# RENESAS TECHNICAL UPDATE

Product Category	MPU&MCU	Document No.	TN-H8*-A345A/E	Rev.	1.00
Title	Specification change of port C in the H8/36077 Group		Information Category	Technical Notification	
Applicable Product	H8/36077 Group	Lot No.	Reference Document	H8/36077 Group Hardware Manual (REJ09B0216-0100 Rev.1.00)	
		All lots

Figure 15.14 Example of External Clock Input

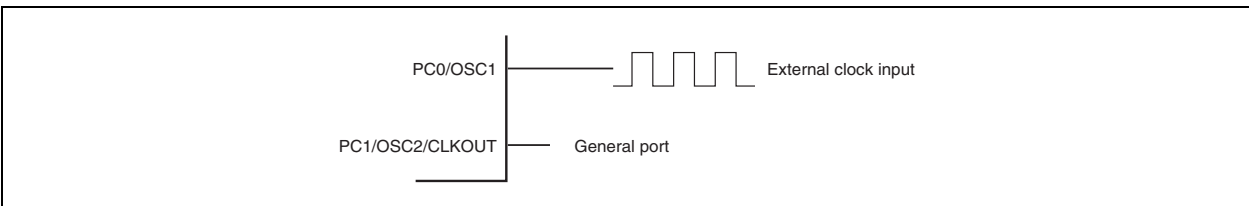
5.5.3 Inputting External Clock

[Before change]

Figure 15.14 Example of External Clock Input

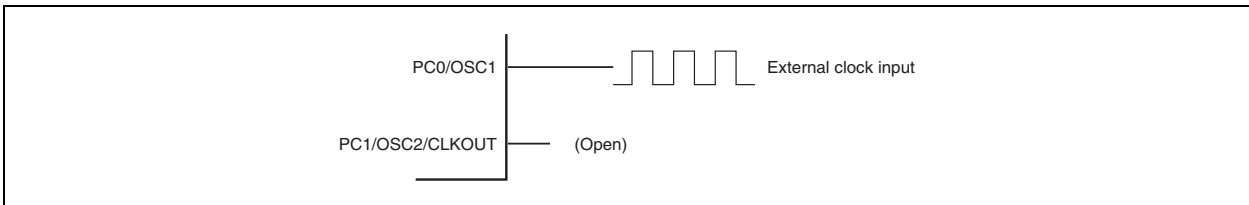
When the OSC1 pin (PC0) is used for input of the external clock, the specification of the OSC2 (PC2) pin is changed as follows.

[After change]

PC1/OSC2 pin — (Open)\*

Note: \* This pin cannot be used as a general port pin.
